Date : January 19, 1962

Subject : Current Configurations of Pressure Suit and Parachute

FULL PRESSURE SUIT 1962
OXCART

THE PROBLEM:

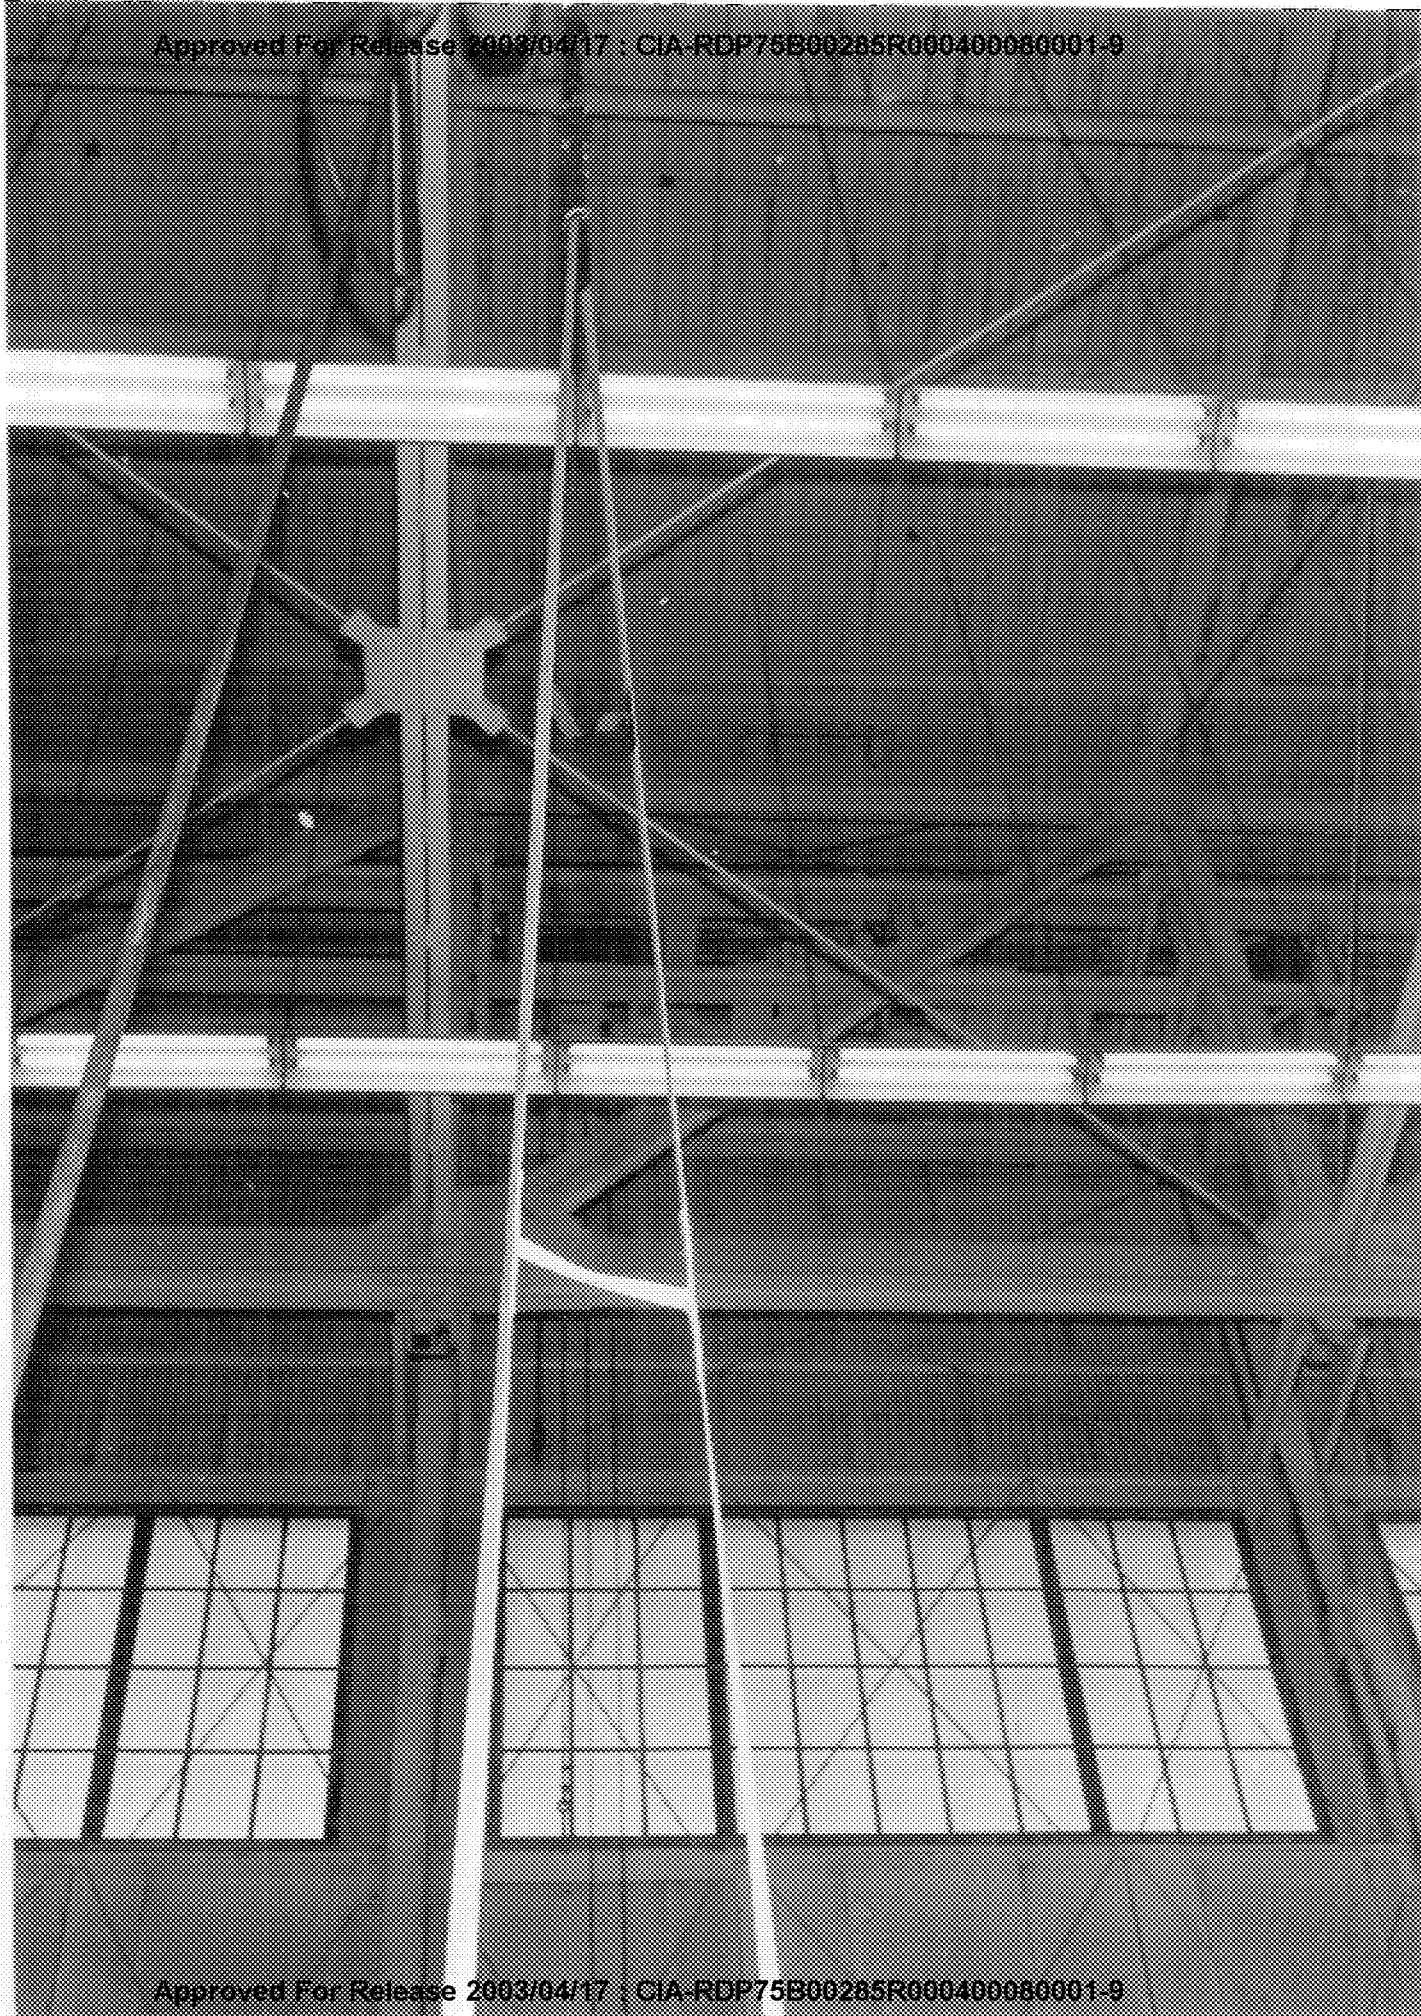
FIRST STAGE SUSPENSION
FITTINGS EXERT PRESSURE ON NECK
RING IMMOBILIZING THE HEAD
AND SUBJECTING NECK TO STRESS.

FIRST STAGE SUSPENSION FITTINGS:

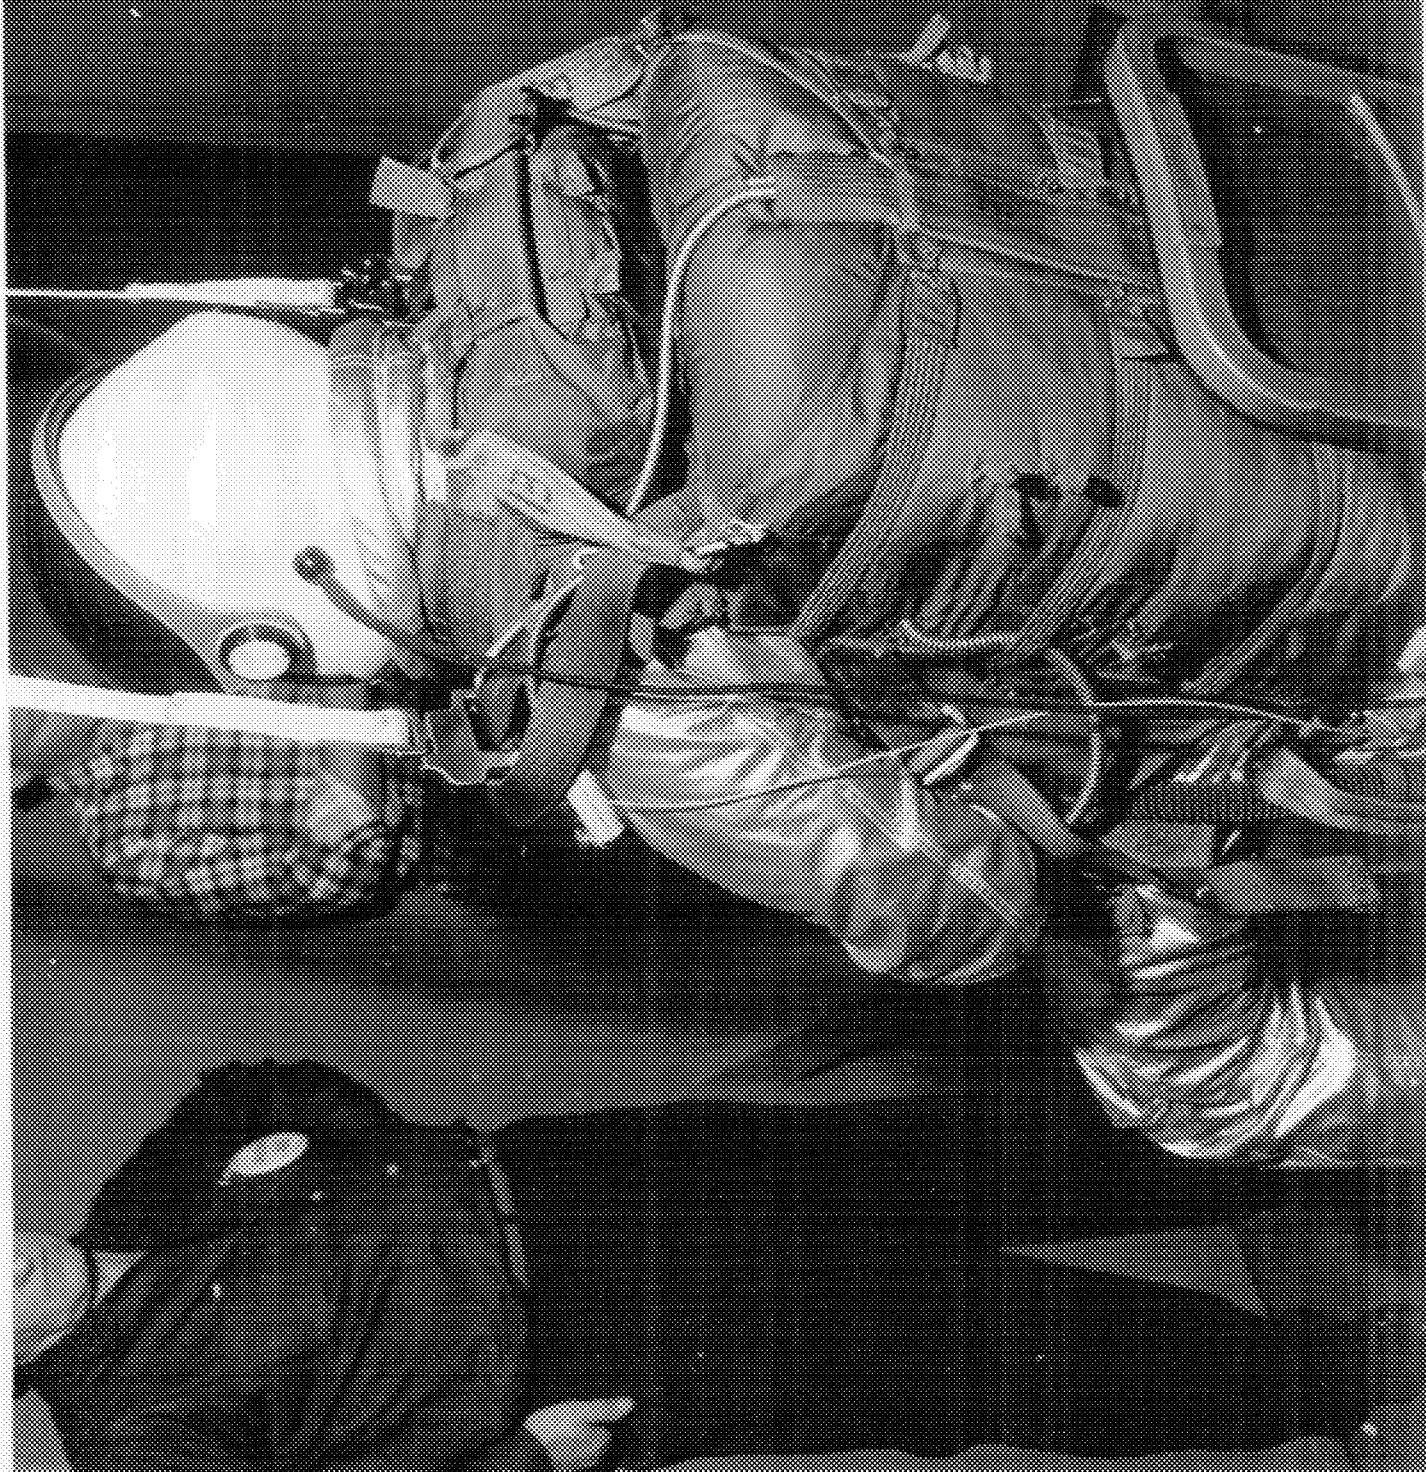
OBJECTIONABLE NECK PRESSURE
AND MOBILITY PROBLEMS IN SEAT

STOWAGE OF FITTINGS UNDERNEATH
NECK RING

a) NECK SPREADER COLLAR ADDED

b) FIRST STAGE FITTINGS MOVED AFT
1 1/2 INCHES AND OUTBOARD ON SEPARATE SUSPENSION
WEB

a) FIRST STAGE FITTINGS MOVED AFT $1\frac{1}{2}$ "
AND OUT BOARD ON SEPARATE SUSPENSION
WEBS.

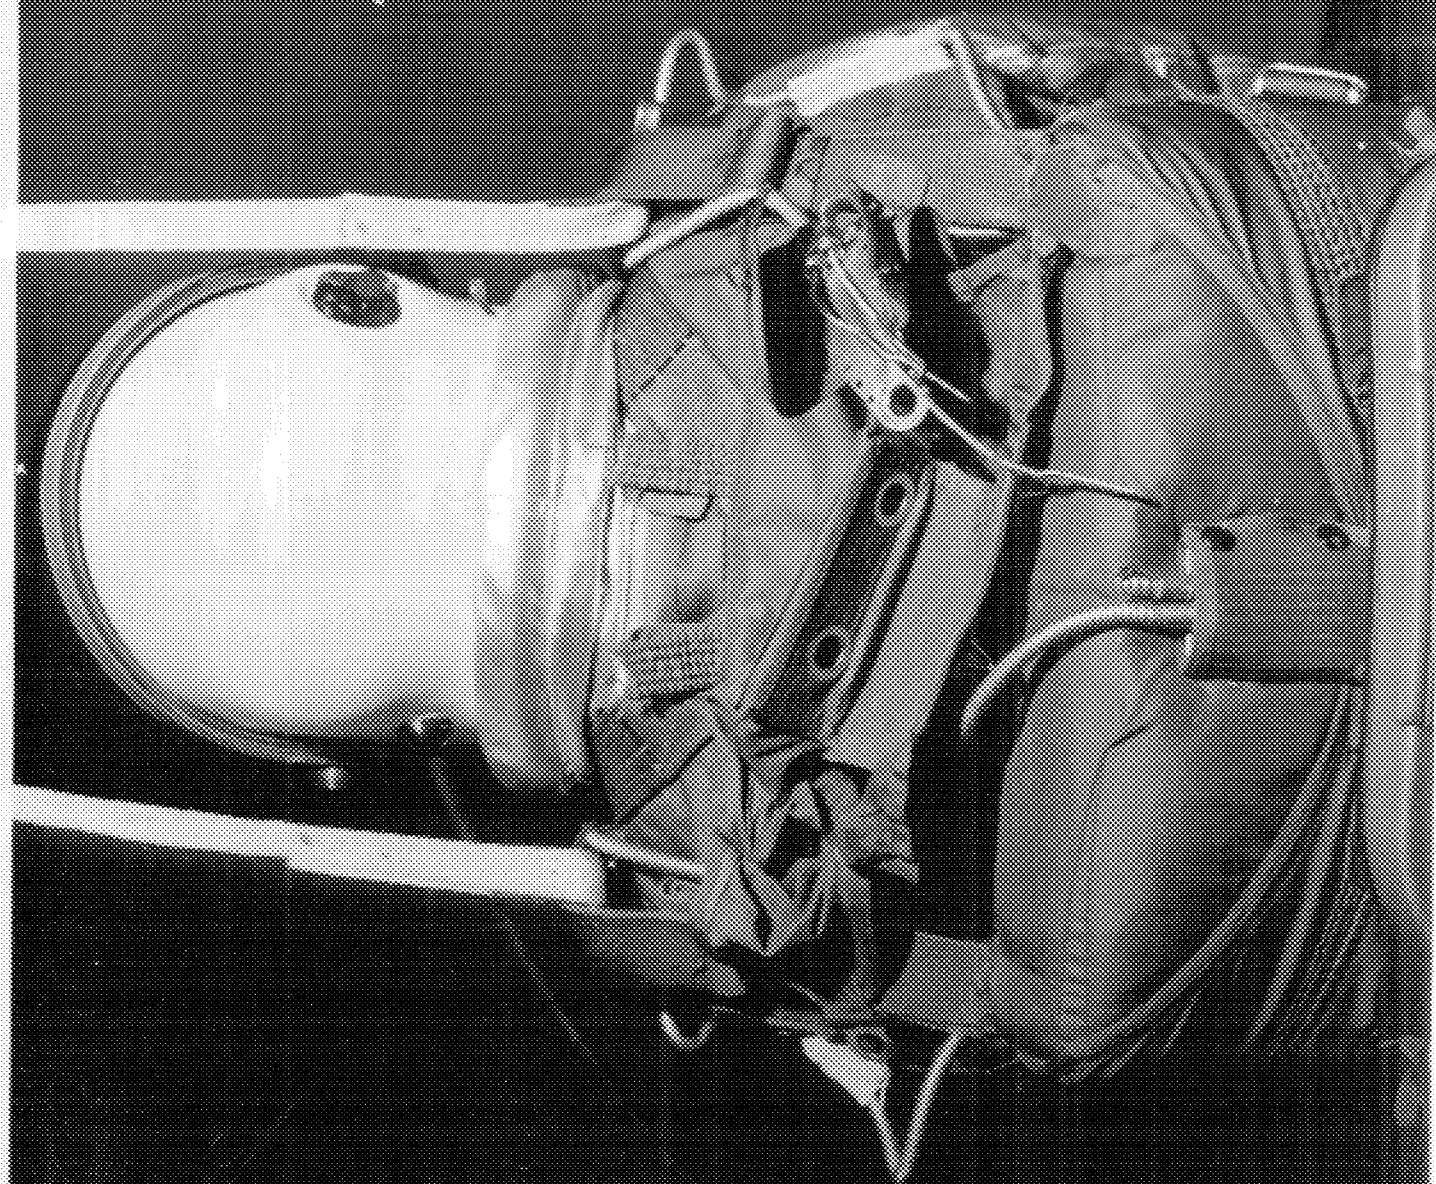
a) IMPROVED MOBILITY IN SEAT OVER
NECK SPREADER COLLAR

4) FIRST STAGE SUSPENSION FITTINGS,
ALTHOUGH IMPROVED, STILL INTERFERE
WITH HELMET & NECK RING

CONSIDERED ~~MOVING~~ ROTATING FIRST STAGE
FITTINGS 90° TO CLEAR NECK RING AND
HELMET

[] WITHOUT SUIT - NECK SPREADER COLLAR

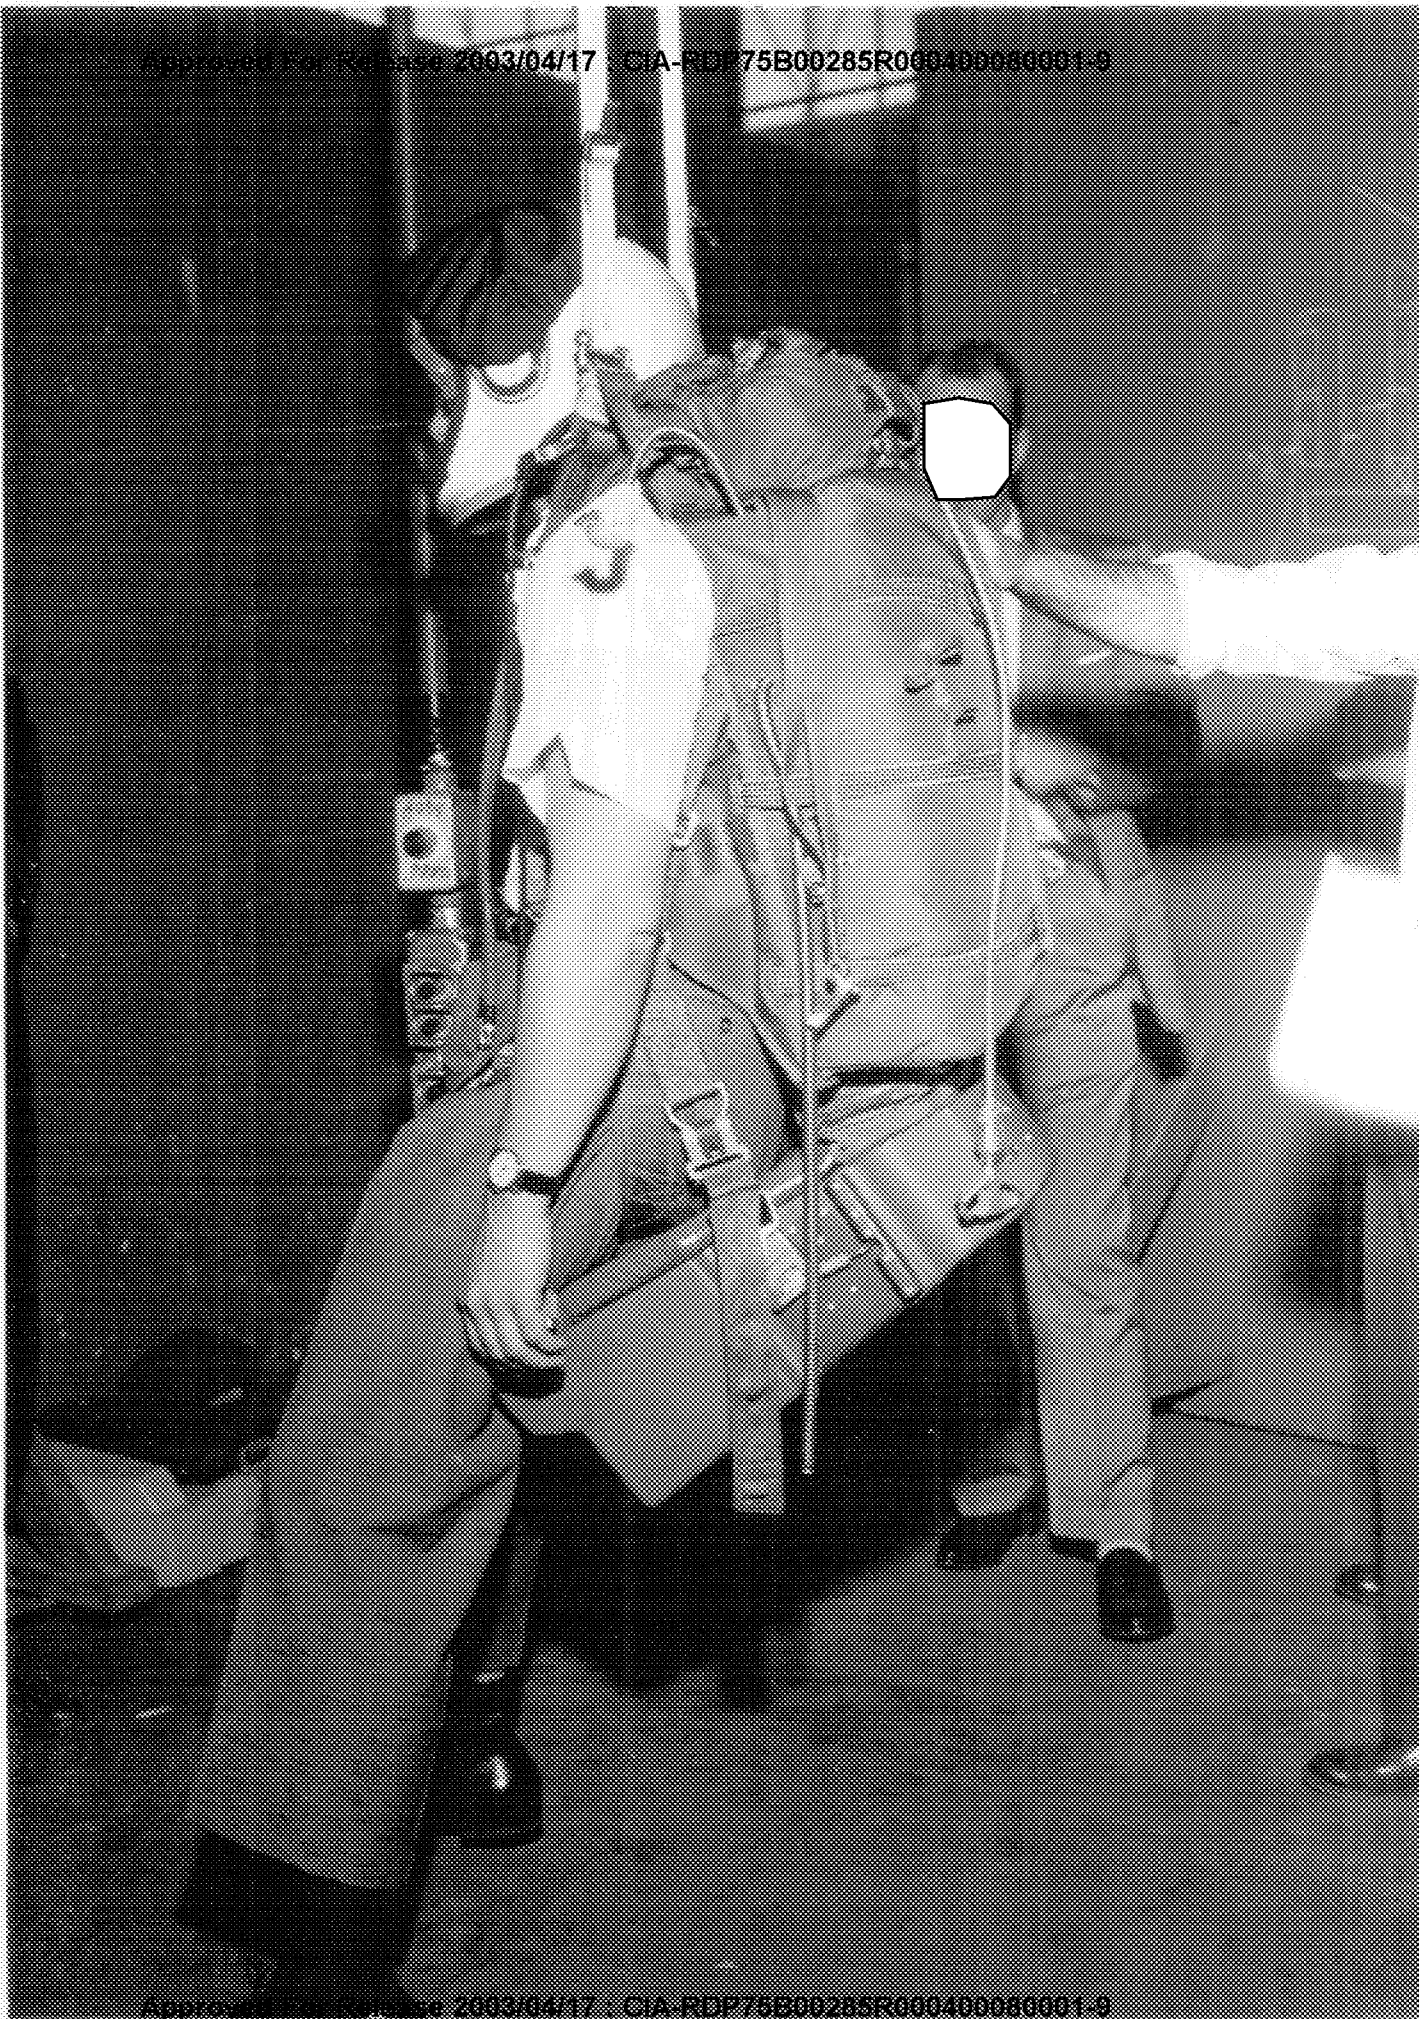
a) COMPLAINS ABOUT ^{CHEST} ~~NECK~~ PRESSURE -
CONSIDERS HIGH

b) CONSIDERS GROIN COMFORT OK

c) SUSPENSION LINE THRU C.G. APPEARS OK.
FOR COMFORT
